# Field Revision Request

Project Cooper Nuclear Station

FRR No. NPPD-91-35

Title: Procedure for Ultrasonic Examination of RPV Closure Studs

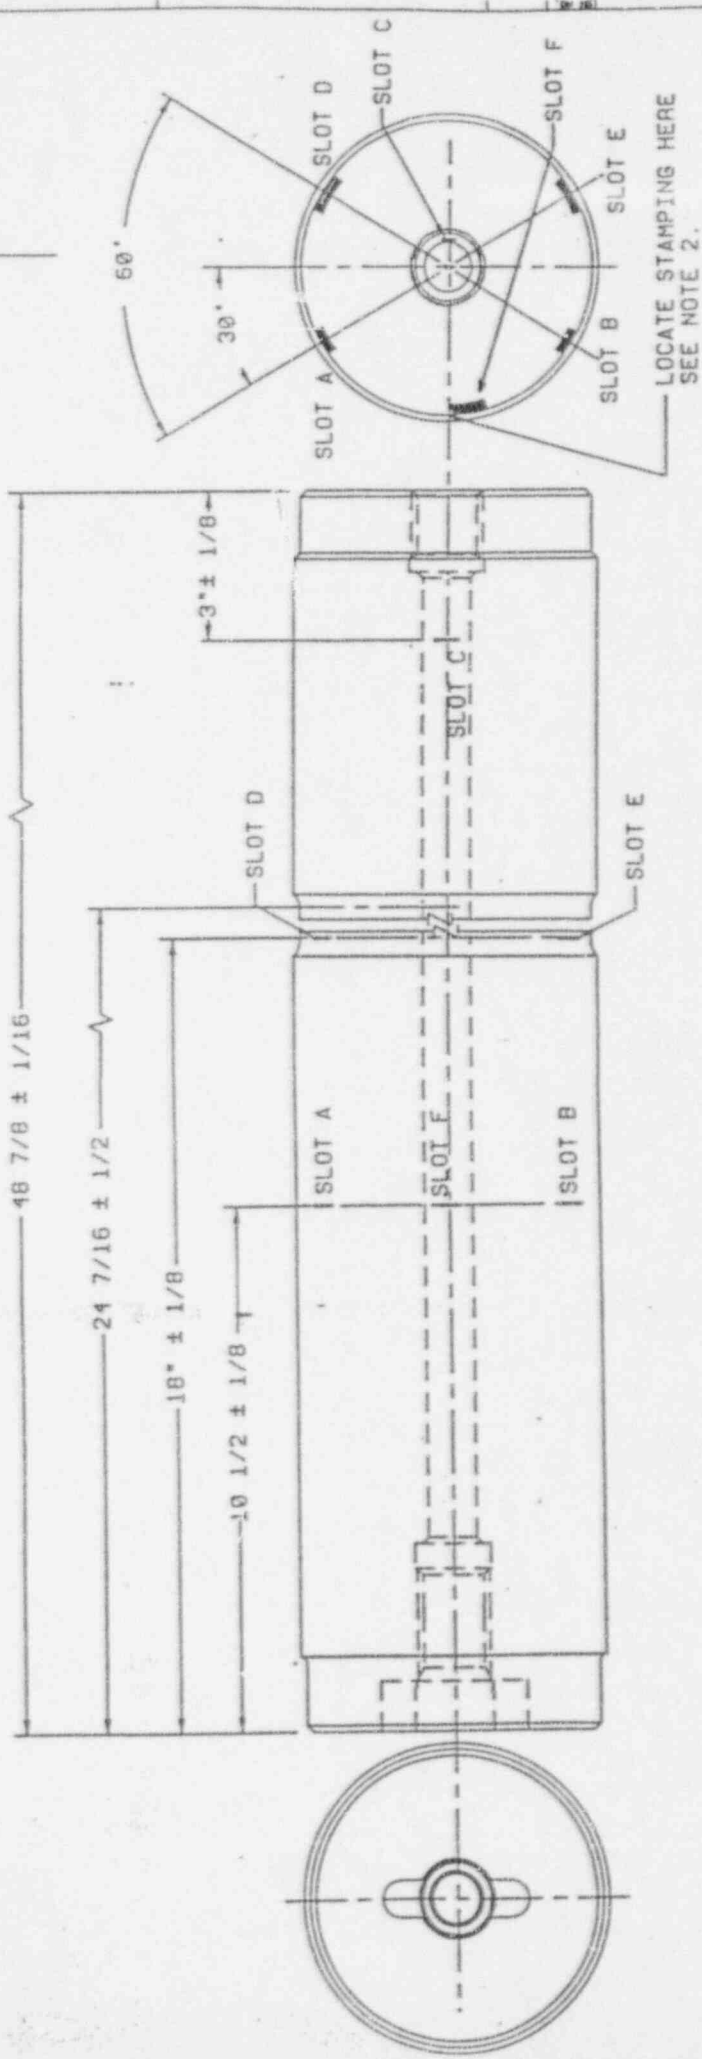
5.3.2 System Calibration and construction of DAC's shall be performed using a 2 (two) Zone technique on a full length Stud Calibration Block. Zone 1 (one) shall cover the metal path range from 0" - 24 7/16" minimum, as measured from the nut end of the block. Zone 2 (two) shall cover the metal path range from 24 7/16" - 48 7/8" minimum.

5.3.3 The Zone 1 (one) DAC shall be obtained using a 5.0 MHZ Nominal Frequency Transducer from the nut end of the block. Obtain signals from slots A and D in the Calibration Block. Set the higher amplitude.

response to 80% FSH. Mark the signal's position and amplitude on the CRT. Without changing gain, obtain a response from the remaining slot. Mark the position and amplitude on the CRT. Connect these points and extrapolate them to cover the examination range. This is primary reference level for Zone 1. Mark a second curve 20% of primary reference level on the CRT. Record instrument settings and DAC's on the Calibration Data Sheet.

5.3.4 The Zone 2 DAC shall be obtained using a 10.0 MHZ nominal frequency transducer from the flange end of the block. Obtain signals from slots A and D in the calibration block. Set the higher amplitude response to 80% FSH. Mark the signal's position and amplitude on the CRT. Without changing gain, obtain a response from the remaining slot. Mark the position and amplitude on the CRT. Connect these points and extrapolate them to cover the examination range. This is primary reference level for Zone 2. Mark a second curve 20% of primary reference level on the CRT. Record instrument settings and DAC's on the Calibration Data Sheet.

FIGURE 1

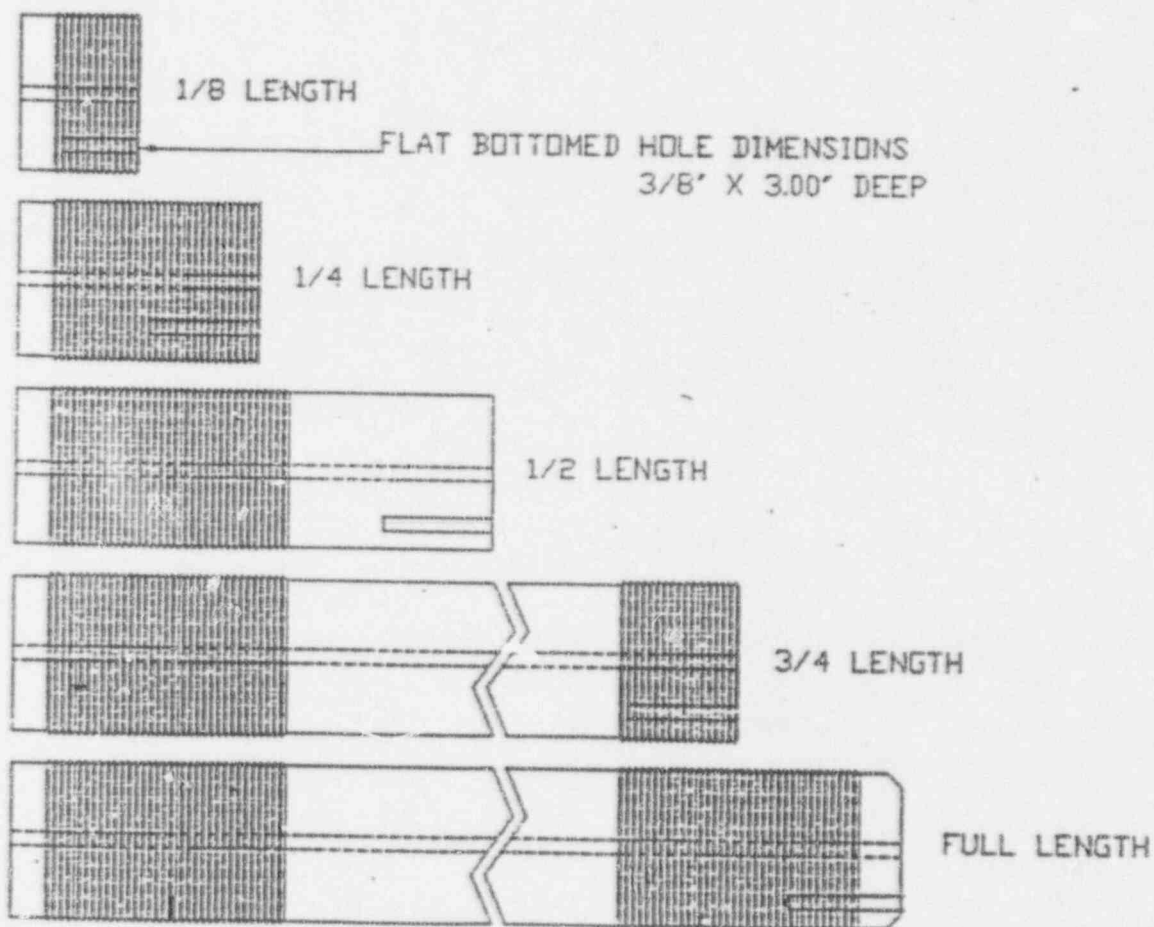
#1 Delete Paragraphs 5.3.1, 5.3.2, 5.3.3, and 5.3.4. Replace with new 5.3.1, 5.3.2, 5.3.3, 5.3.4, to read as follows:

#2 Delete 5.3.4.1, 5.3.4.2, 5.3.4.3, 5.3.4.4, 5.3.4.5, 5.3.4.6.

5.3.1 Sweep Range Calibration. Using a suitable Calibration Block, adjust the instrument sweep to display a minimum of 50" of Metal Path.
